# Certificate of Appropriateness

**Property** 2549 N. TERRACE AV. North Point North Historic District  
**Description of work** Applicant proposes to remove existing porch flooring and replace it with new wood decking. Porch steps and wingwalls will be removed and new wood steps constructed. The decorative iron railings and posts will be removed and replaced with wood railings and new wood columns with Tuscan style capitals and bases.

**Date issued** 11/8/2022 PTS ID 115344 COA Rebuild rear porch

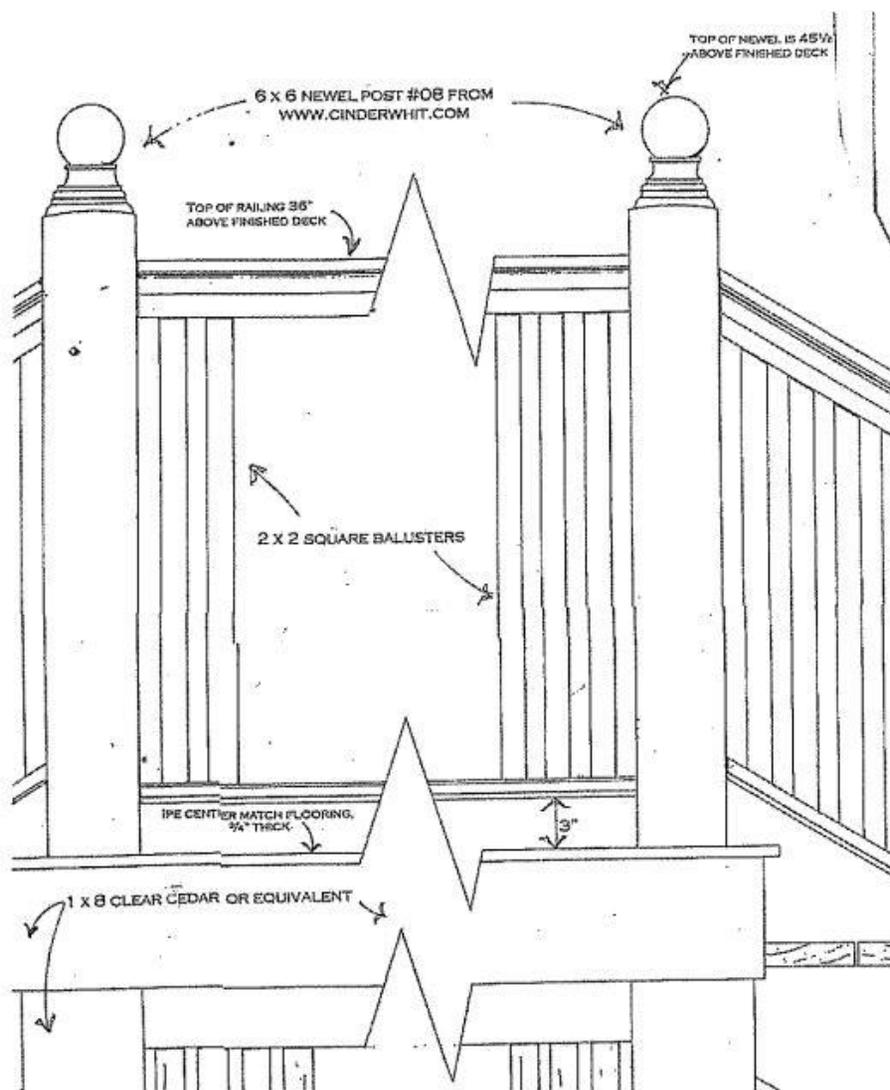
**Top rail for both guardrails  
 and handrails has to be  
 graspable and shaped as in  
 drawing. Bottom rail needs  
 beveled edges to shed water  
 and avoid rot.**

**Note: Bottom rail of guardrail is 3 inches above porch deck. Balusters are 2 inches by 2 inches and set 1-1/4 inch apart. Tops of newels are 45-1/2 inches above porch deck. Top railing is 36 inches above porch deck.**
